Re: **Addendums and Dividers for Approved Work Plan dated 28 July 2000**  
**Project No. 805169**

### Work Plan – Removal of Asbestos and Vermiculite at the Libby Asbestos Site

**ADDENDUM NO. 2**  
**Work Plan – Removal of Asbestos and Vermiculite**  
**at the Export Plant, Libby Asbestos Site**  
**28 July 2000**

**ADDENDUM NO. 6**  
**Work Plan - Removal of Asbestos and Vermiculite**  
**at the Export Plant, Libby Asbestos Site**  
**06 September 2000**

**Figure J-2. Proposed Soil and  
Debris Disposal  
Locations  
Vermiculite Mine Site  
Libby, Montana**

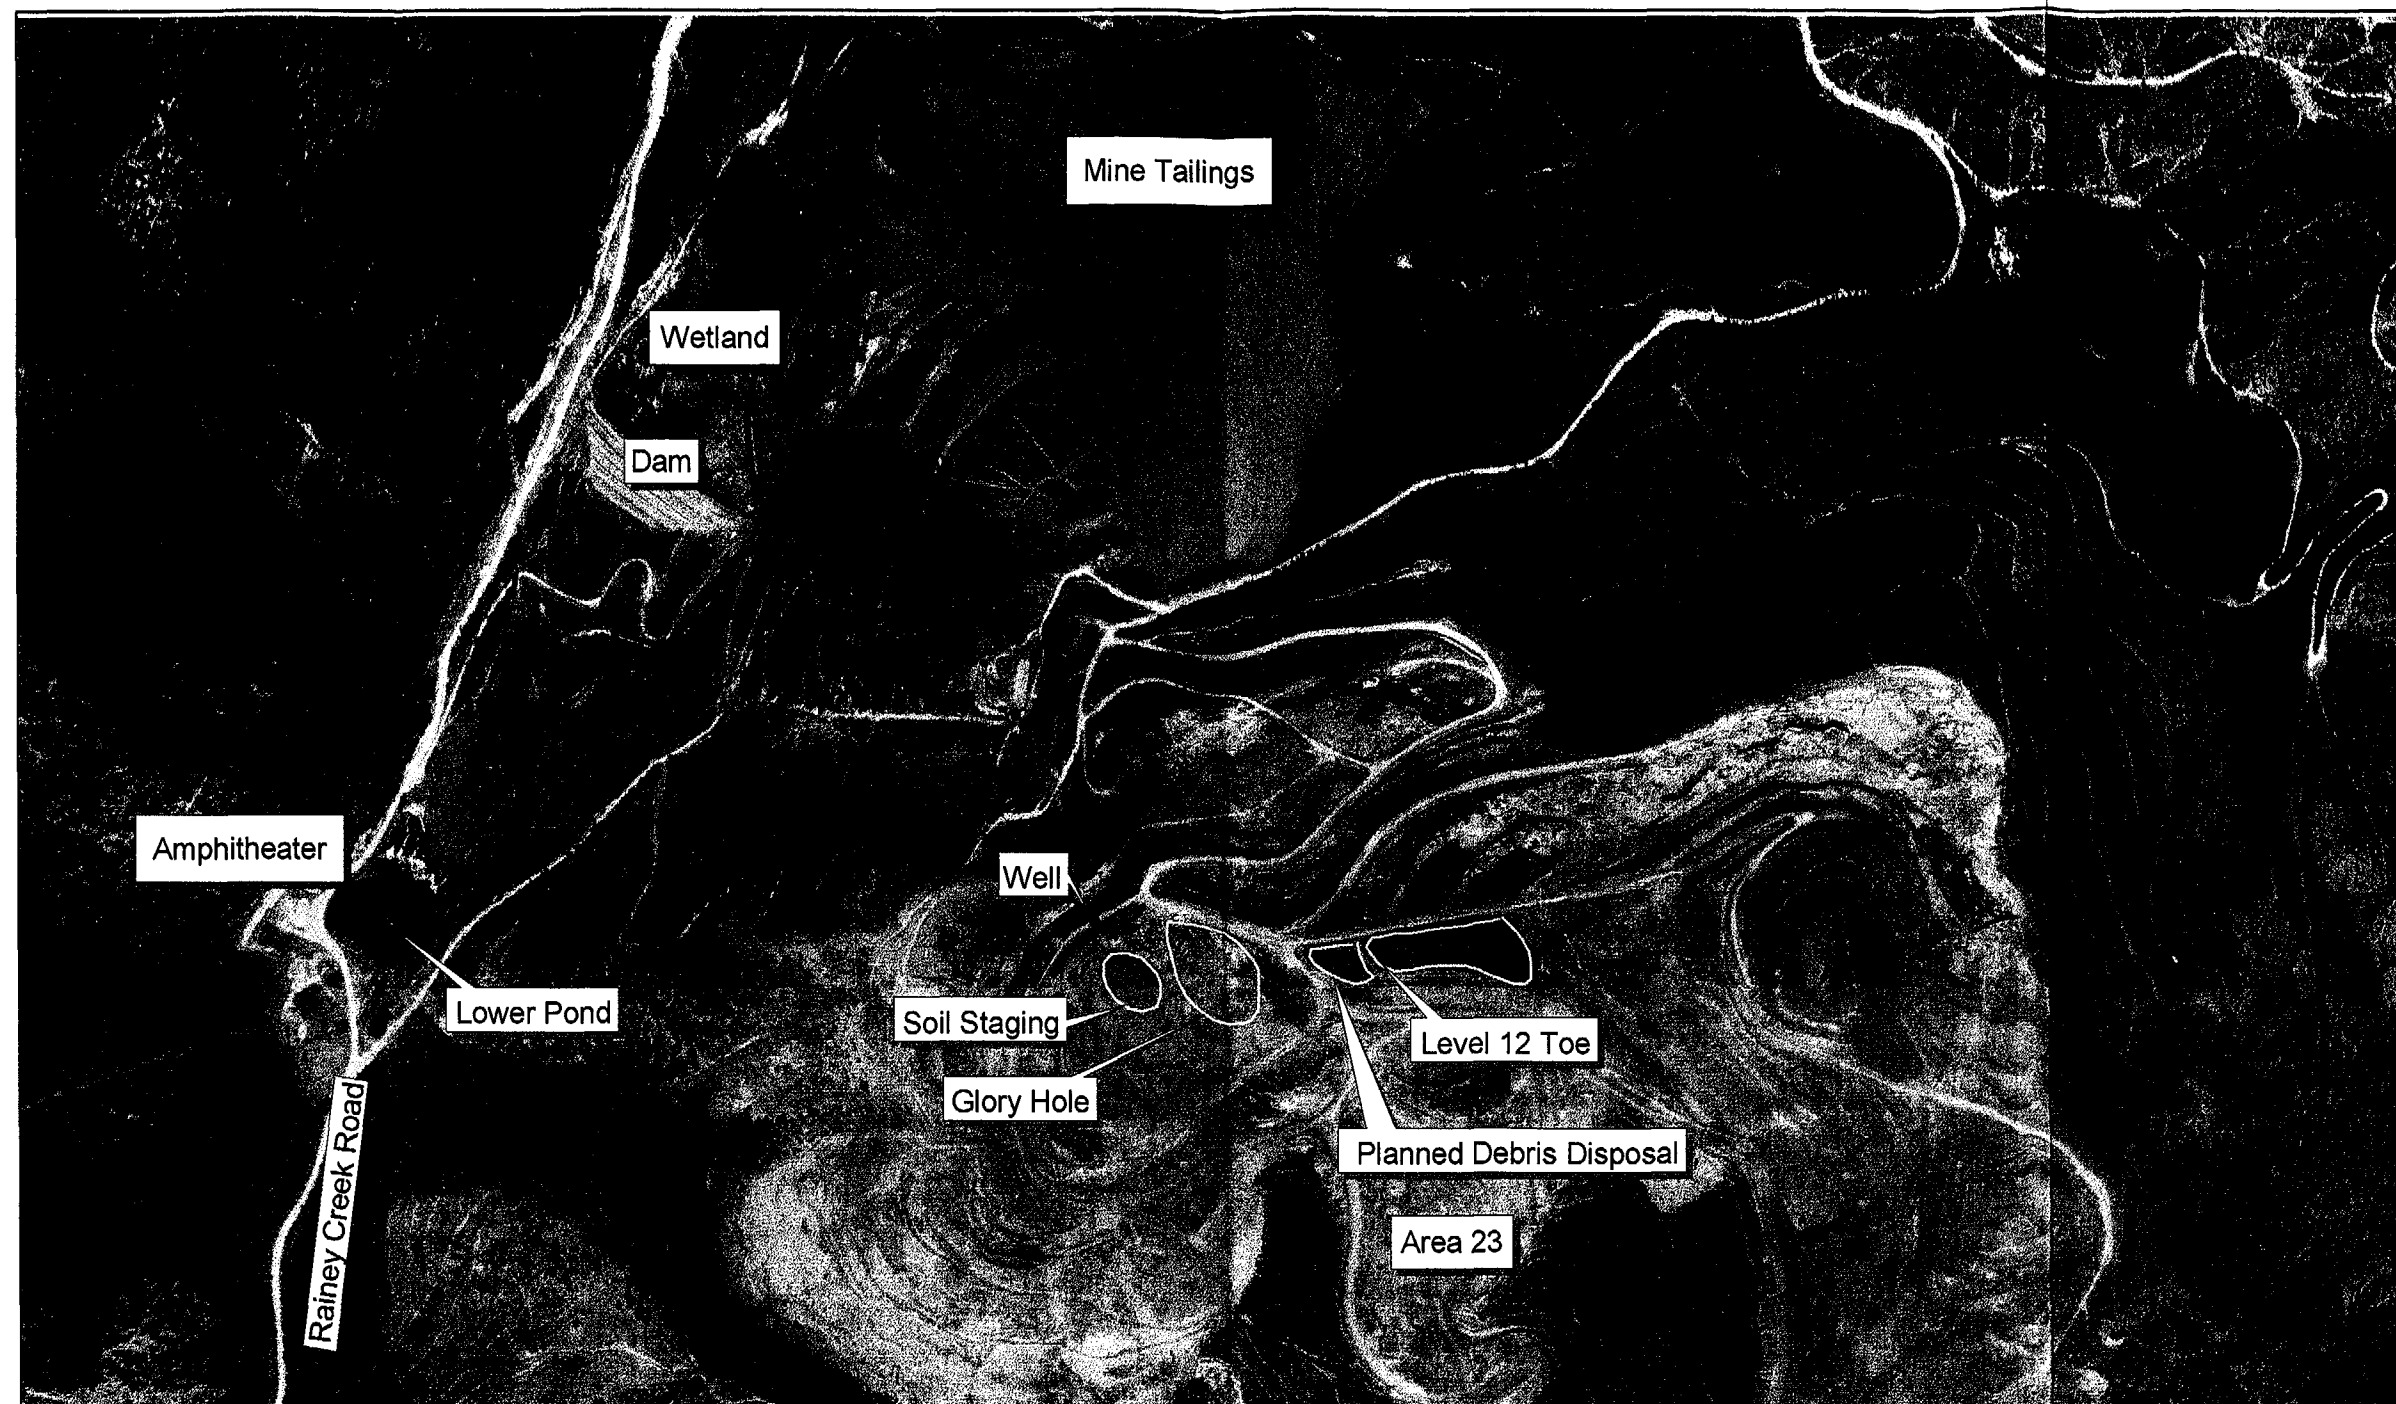
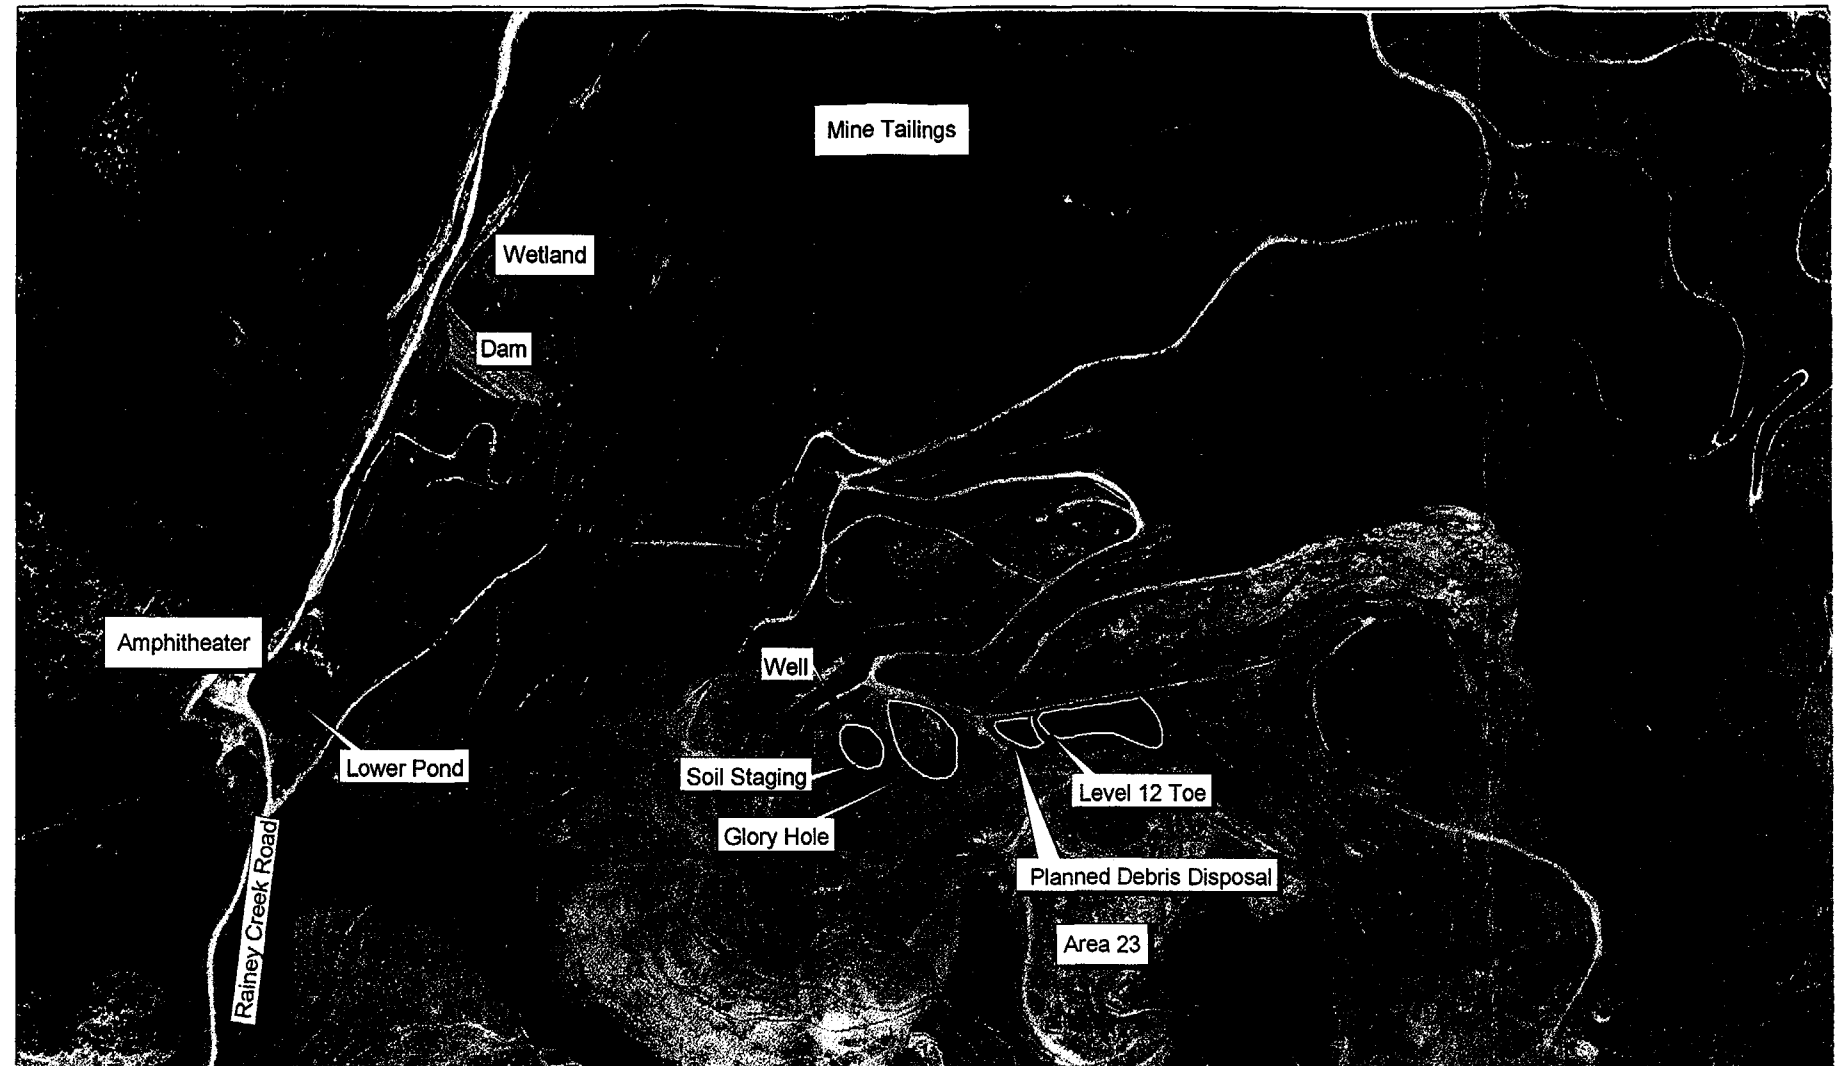
Debris from the Export Plant building abatement activities and vermiculite removal will be hauled to the debris disposal area in trucks and placed in a depression on Level 12 near the toe of a small hill as shown on Figure J-2. It is anticipated that most of the debris material from the abatement will be wrapped in plastic or bagged. If necessary to control wind blown litter, periodic soil cover will be pushed over the top of the debris using a dozer operating at the top of the hill. The cover will consist of existing soil scraped by the dozer off the hill above the disposal area. Alternatively, the material will be moistened daily to control wind dispersal.

**Figure J-3. View Looking West from Top of Level 12**

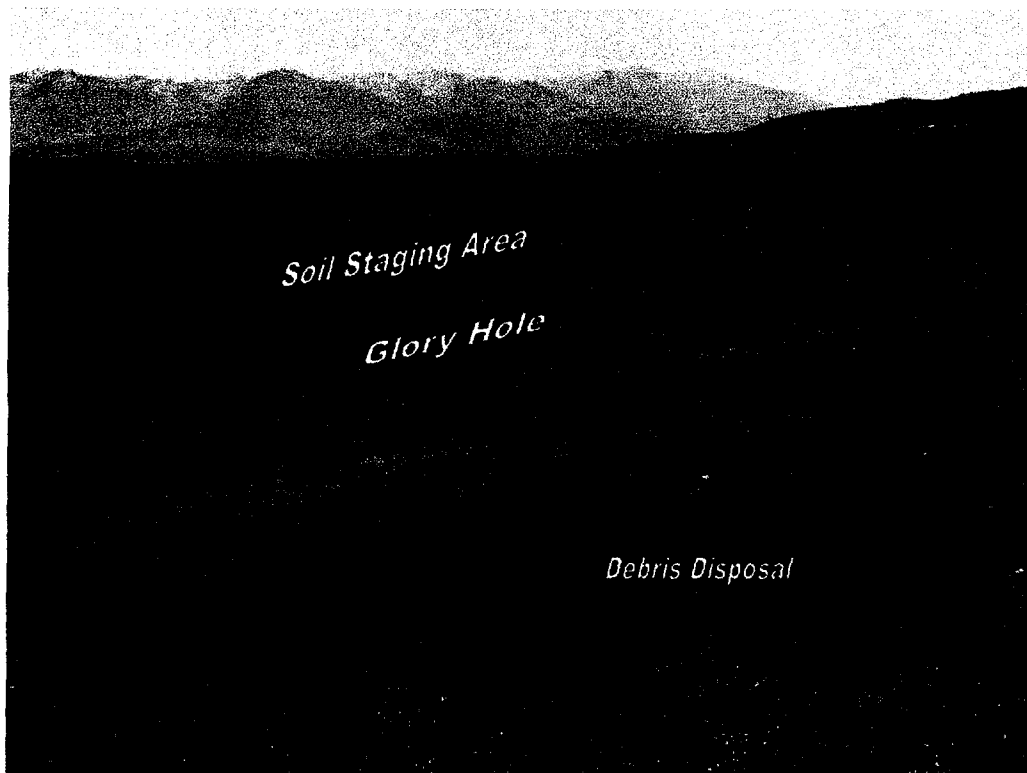
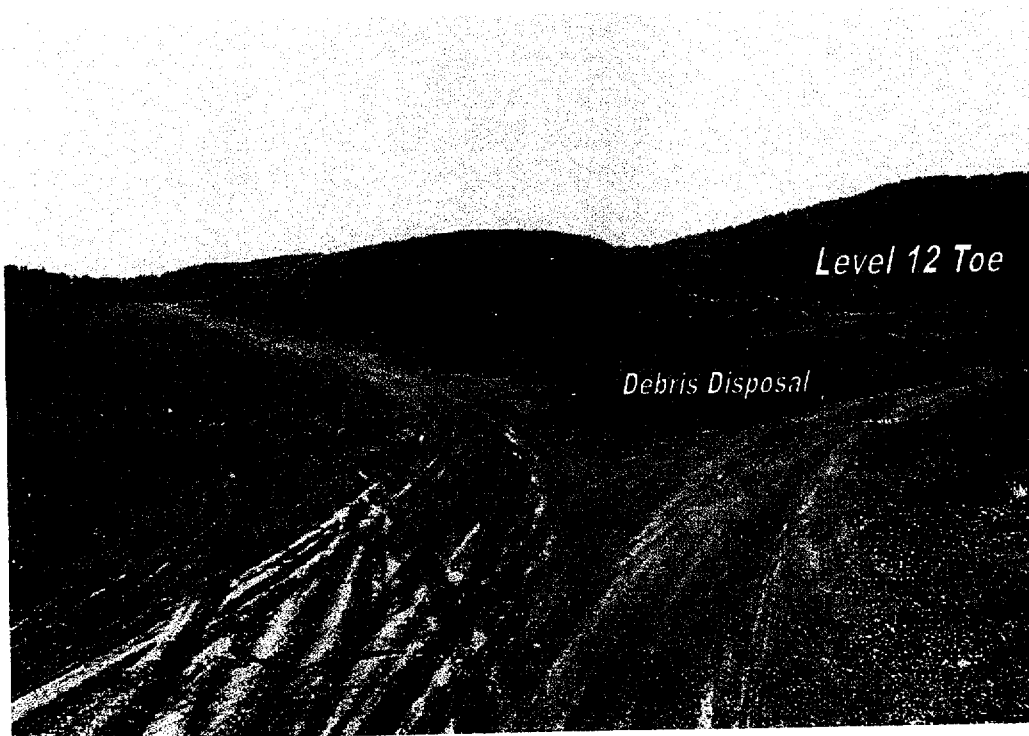
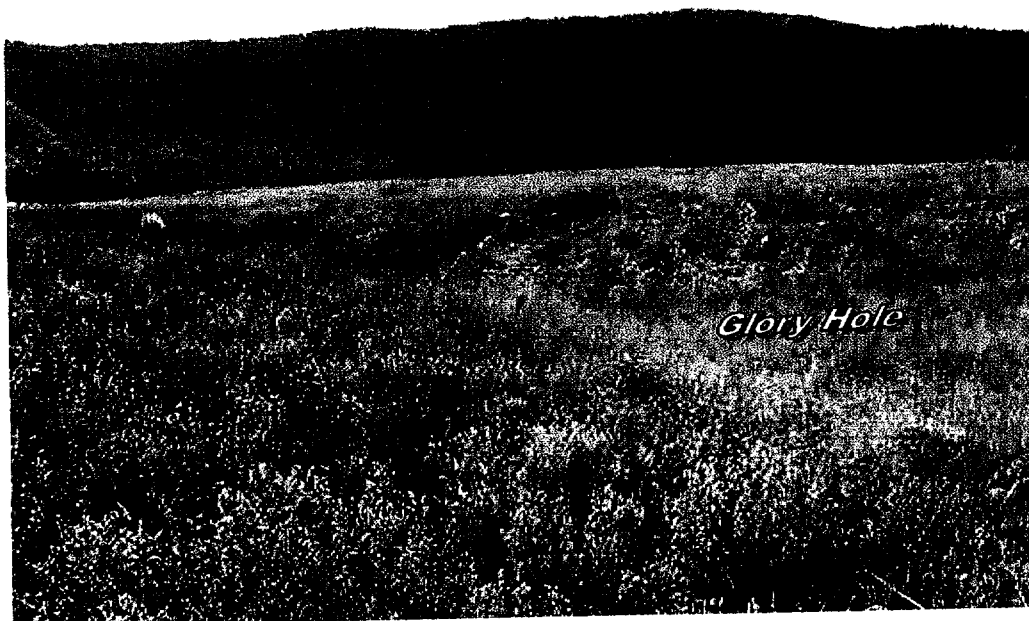
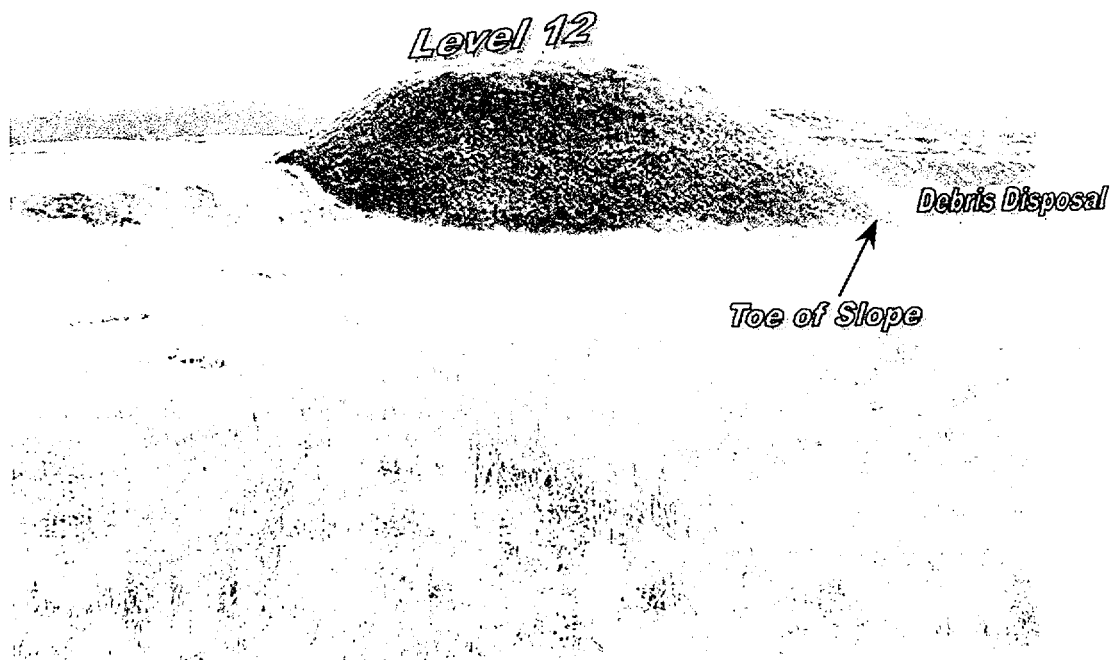
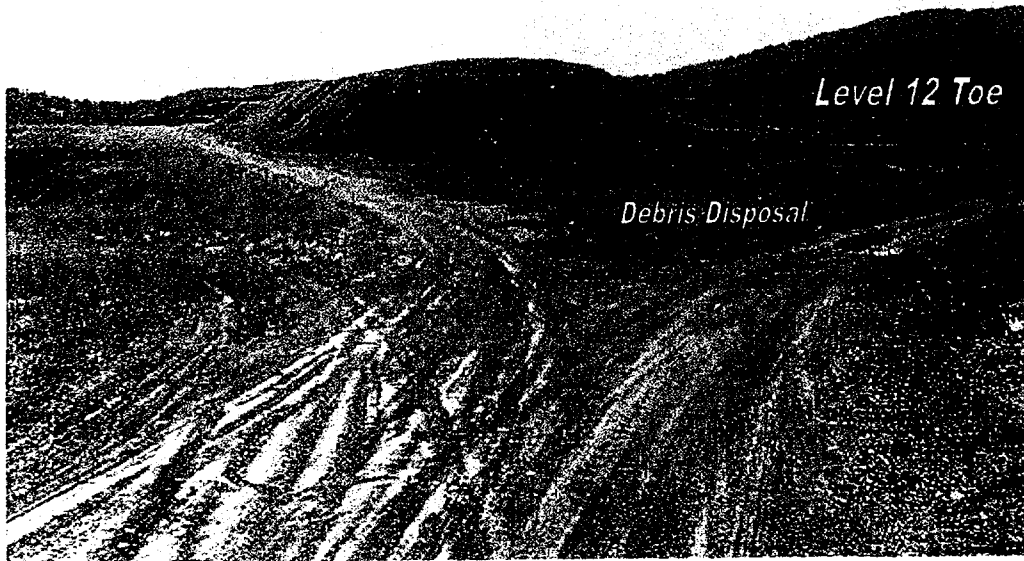
As agreed upon with the appropriate project regulatory representatives (Paul Peronard-EPA; and John Constan-Montana DEQ), two areas at the mine site have been identified for disposal of soil and debris associated with the Export Plant cleanup. The two areas are shown on Figure J-2 and noted as the "Soil Staging" area and the "Planned Debris Disposal" area. Soil excavated from the Export Plant will be staged in an area directly west of a large depression known as the Glory Hole. Cleaning debris and non-salvageable material will be placed in a depression known as the Level 12 Toe, directly west of a large mound of dirt and mined material. Photographs of the selected disposal areas are presented as Figures J-3 through J-6.
